WSEO SUBMITTAL

DWG TITLE:
SITE LIGHTING PLAN - SECTIONS 1, 2

E104
 DWG TITLE:
 SITE LIGHTING PLAN -
 SECTIONS 3, 4, 5

Lighting_V2.pdf Markup Summary 12-8-2021

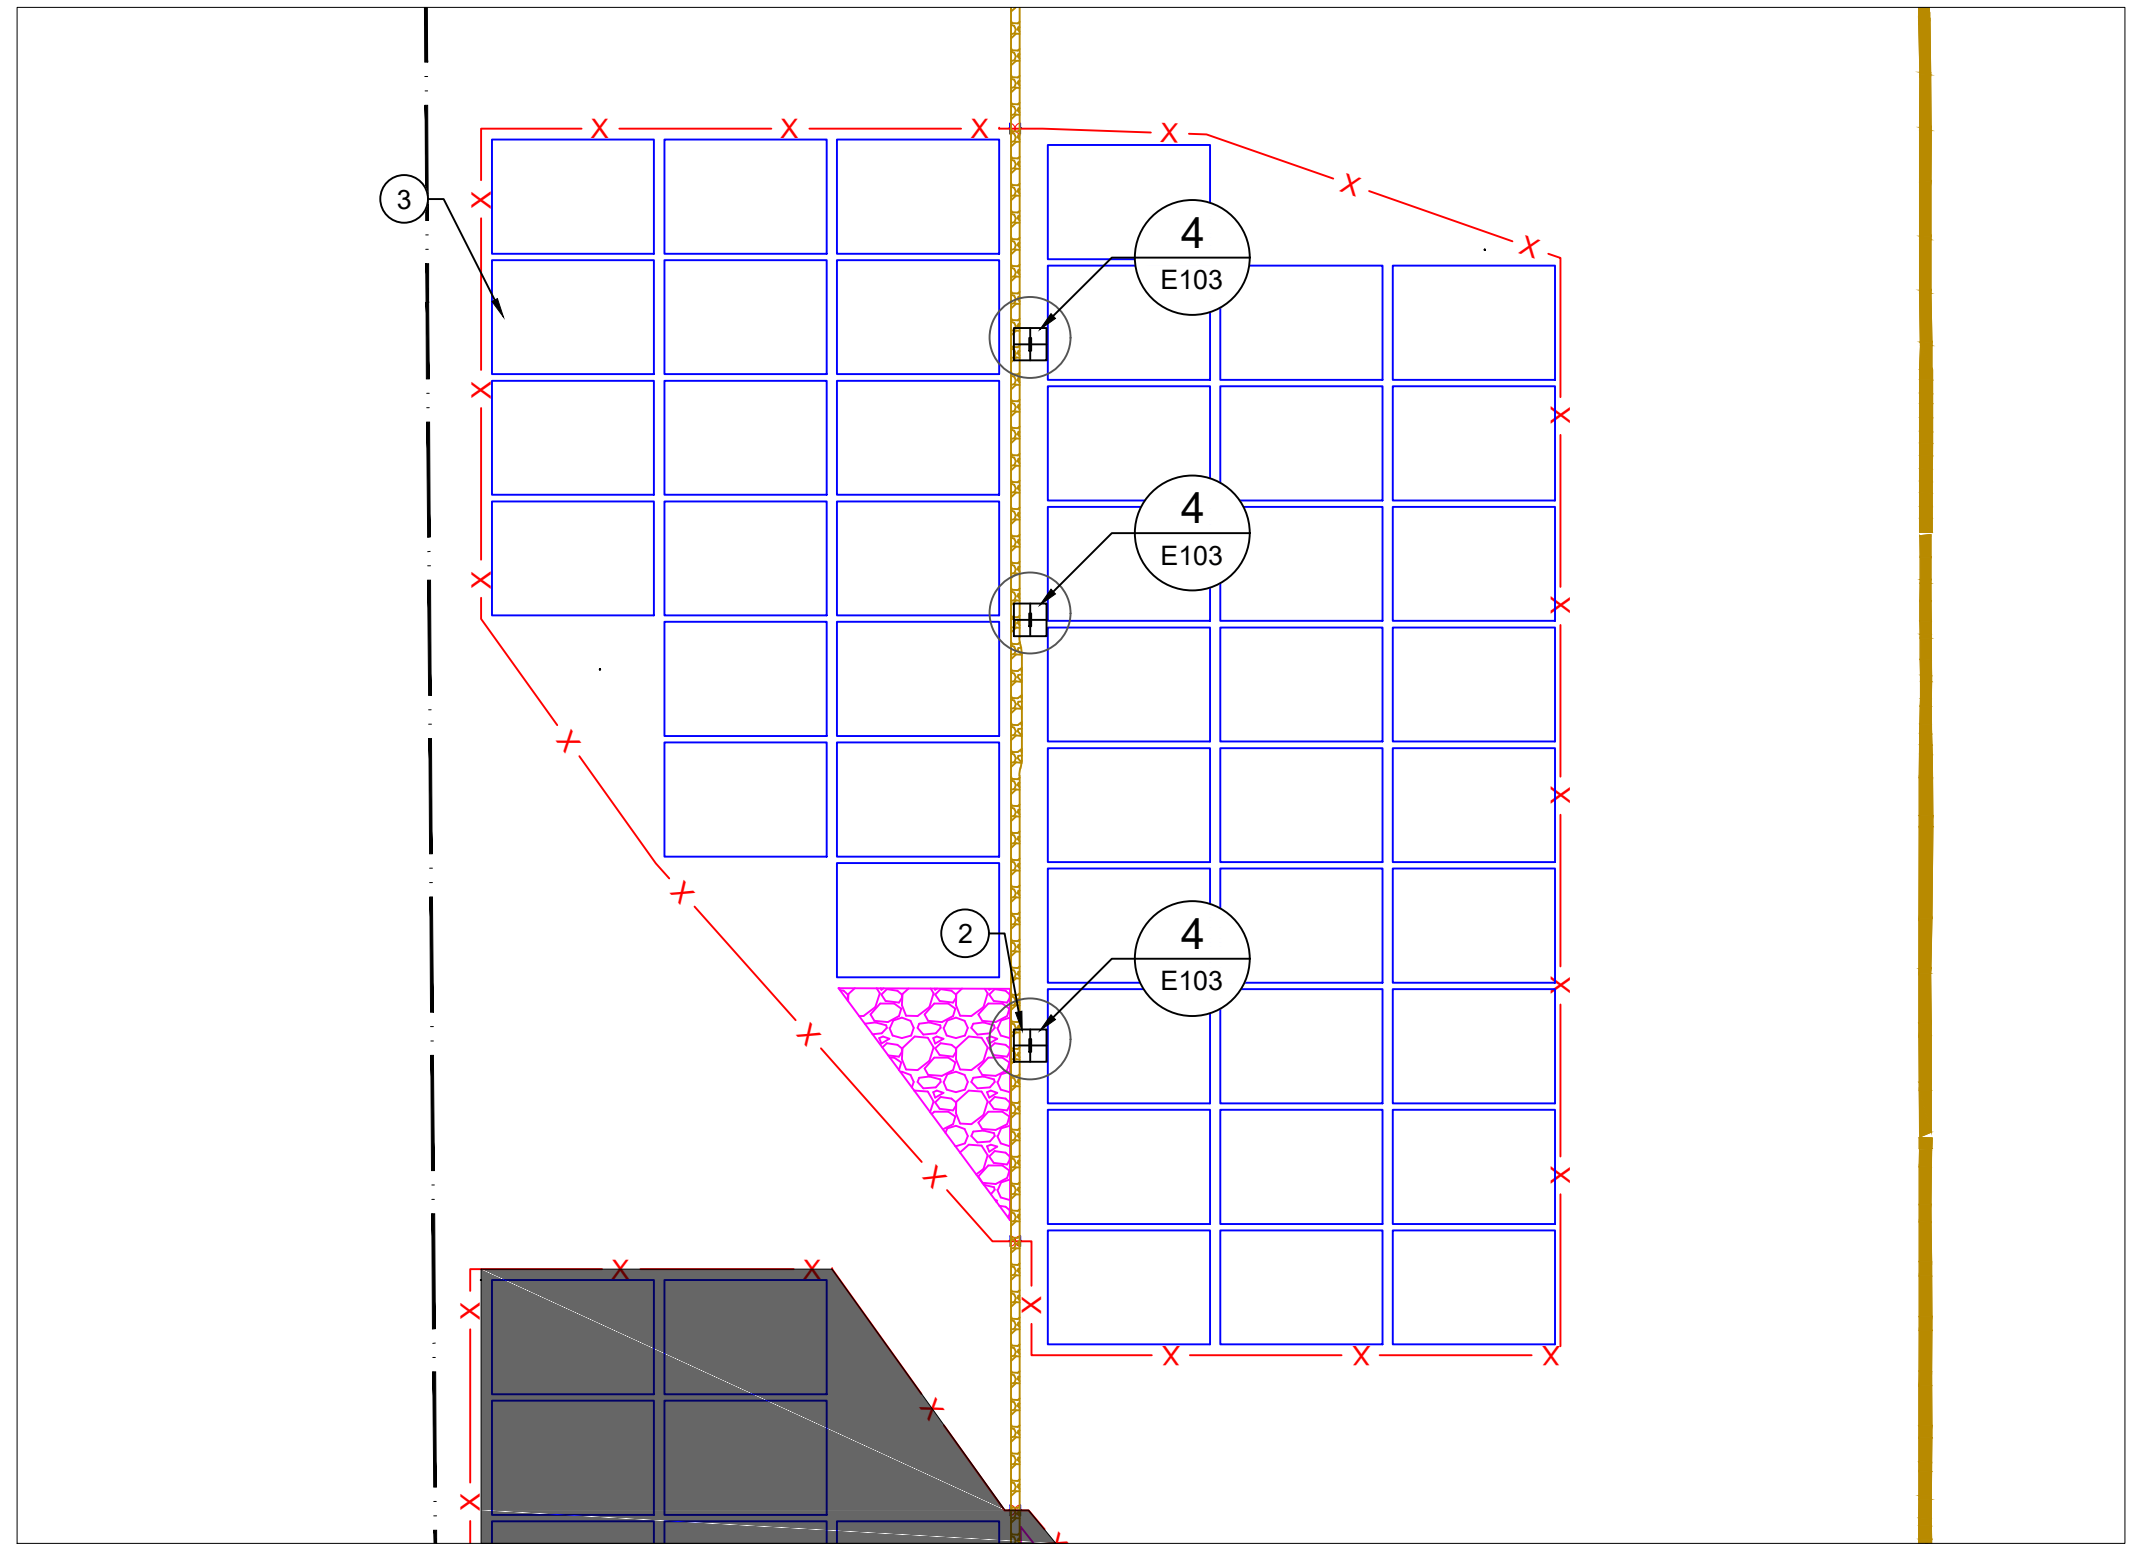
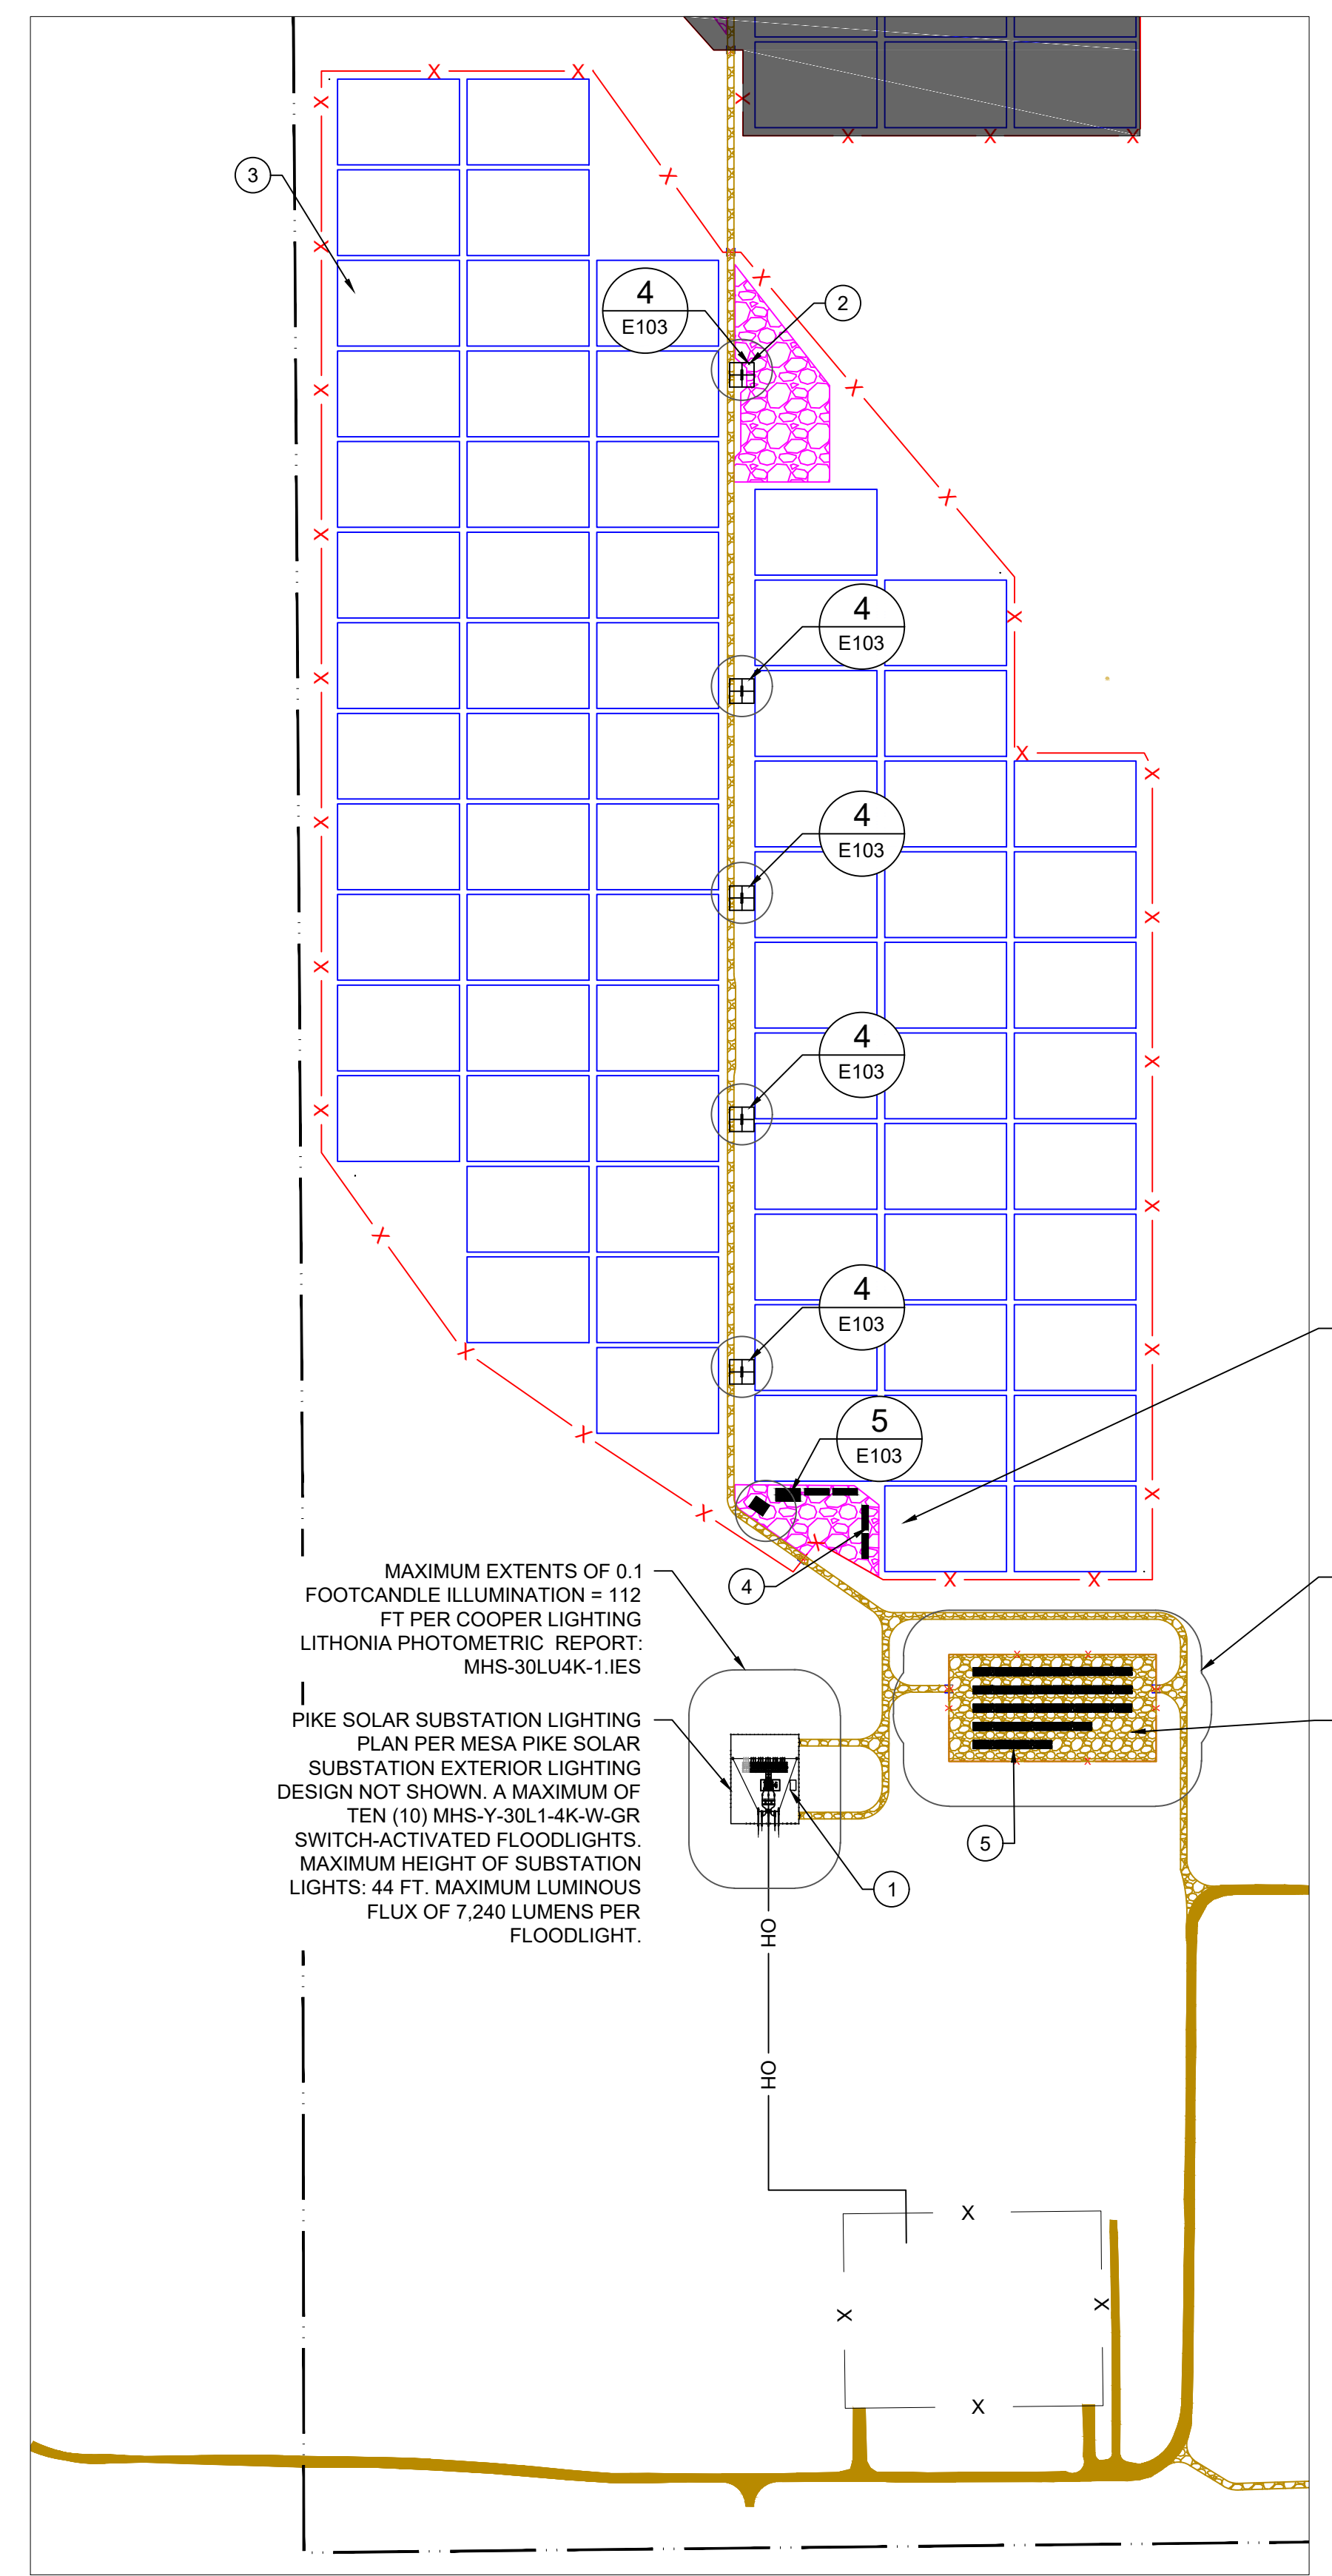
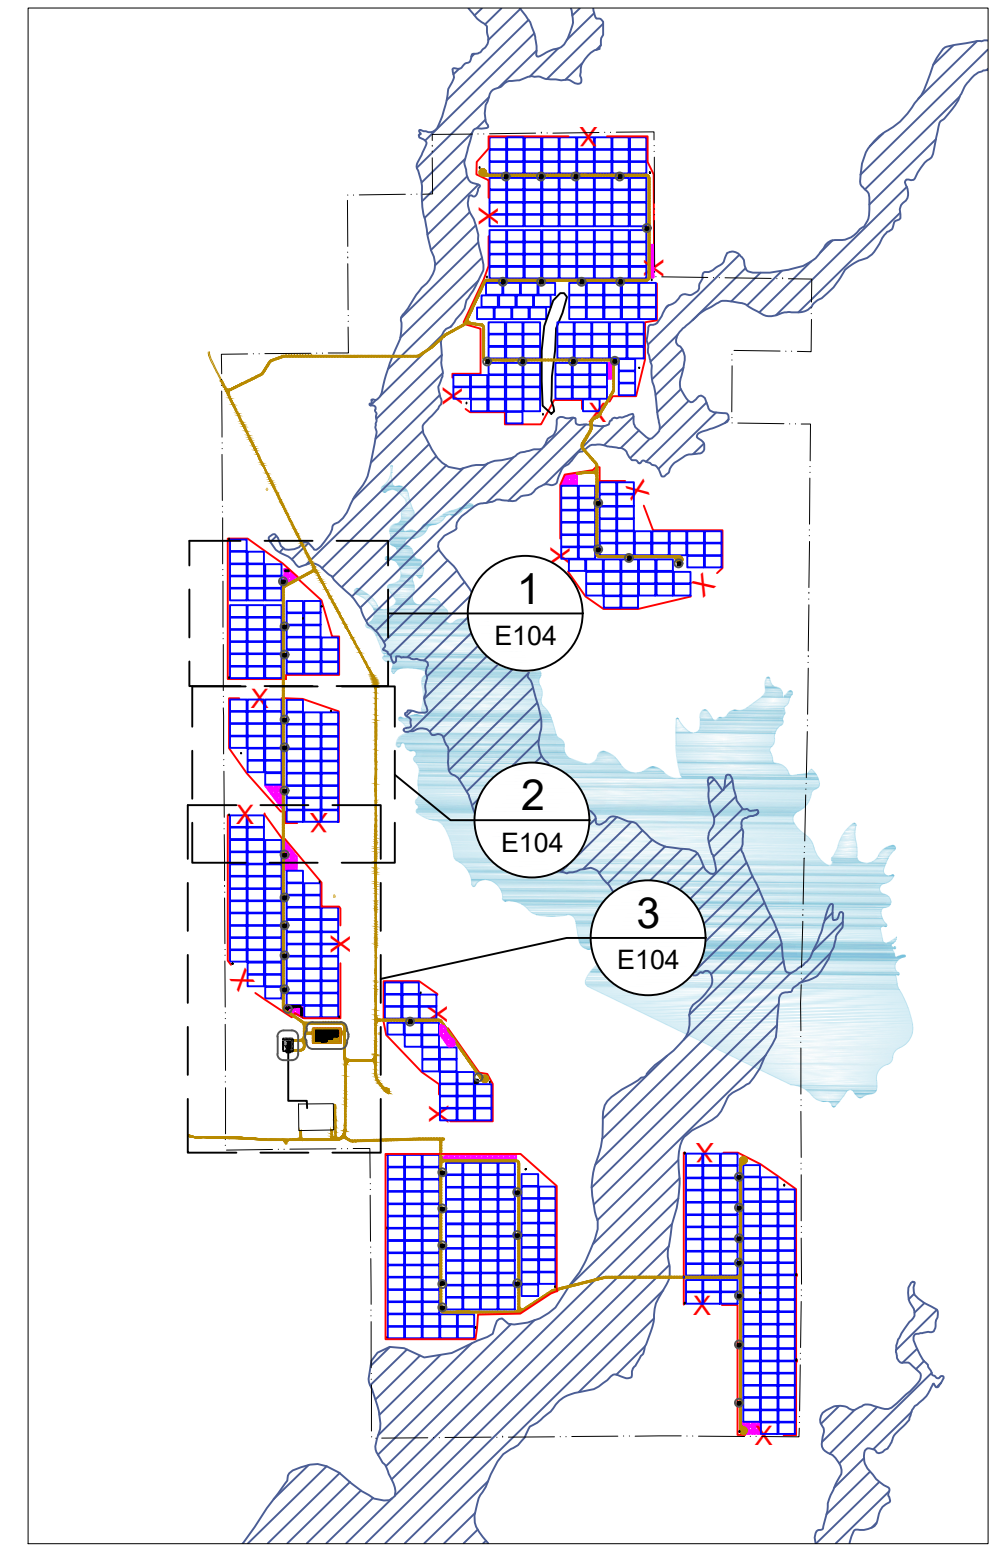
6. Site lighting, where is the service for the site lighting coming from? Are there to be new meters? Please clarify. If new meters show the locations so that a new address can be assigned..

PPRBD comment
